STAFF REPORT

MEETING DATE: September 9, 2015

SUBJECT: **Case #18-15 – 139 Hathaway Road – O'Reilly Auto Parts**

Request by applicant for **Site Plan** approval for new construction of a 7250 +/- SF retail building, with associated landscaping within the existing property, and **Special Permit** for reduction of parking spaces, located in the Mixed Use Business/Industrial B zoning districts (Attachment 1).

ZONING REQUIREMENTS TABLE

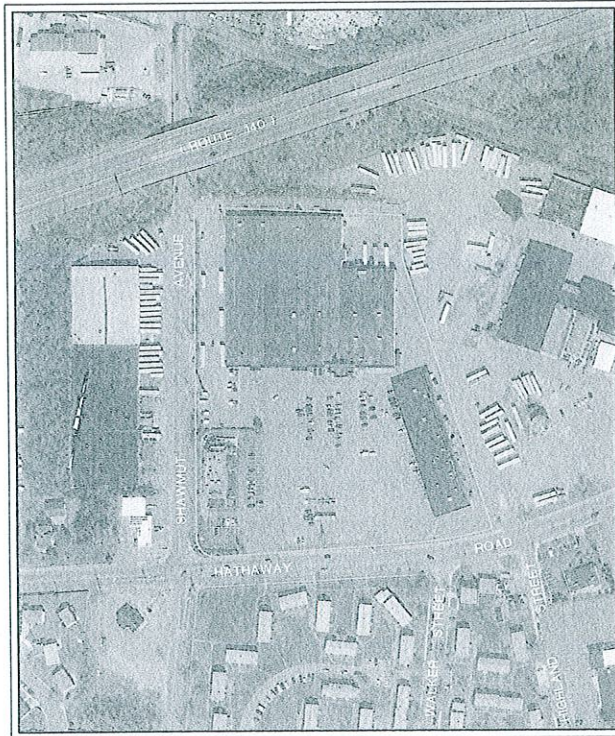
- The Cover Sheet Zoning Requirements Matrix is incomplete. Applicant's agent must add a column heading for Industrial B noting the following from City of New Bedford Municipal Code Appendix B of the Table of Dimensions: Lot Area = 0, Lot Frontage = 0, Setbacks: Front = 25 FT, Side Setbacks = 25 FT (Also correct MUB to read 10 FT, not 0), Rear = 25 FT, Building Height in Stories = 7 (Also correct MUB to read 7, not 100), Lot Coverage = 50%, and Green Space = 20%.

- Grossmans is a 33420 SF business engaged in retail sale of building materials and meets the description under Appendix C – Table of Parking & Loading Requirements, whereby parking and loading requirements for this type of use is *One (1) space per each 400 SF of gross floor area*. A Google search shows Grossmans advertised as a "Home-improvement chain with supplies for kitchen, bath, floors, doors & windows, at discount prices." The parking summary reflects parking for businesses engaged in the warehousing and distribution of goods & materials including building and construction supplies and should be revised accordingly.

- Parking requirements total 484 spaces, less 50 shared spaces, provide the applicant with 434 parking spaces. According to the applicant's agent, there are 398 spaces. The applicant should seek to amend the Special Permit for parking Reduction in addition to the request for shared parking.

- The number of handicap parking spaces provided are not listed on the Cover Sheet.
- One Loading Zone is shown on the Site Plan, meeting the standards of *one loading space for each building containing more than 5000 SF and less than 10000 SF* and should be included in the Matrix.

- The Zoning Matrix must be revised.
- The applicant should seek to amend the Special Permit for parking Reduction in addition to the request for shared parking.
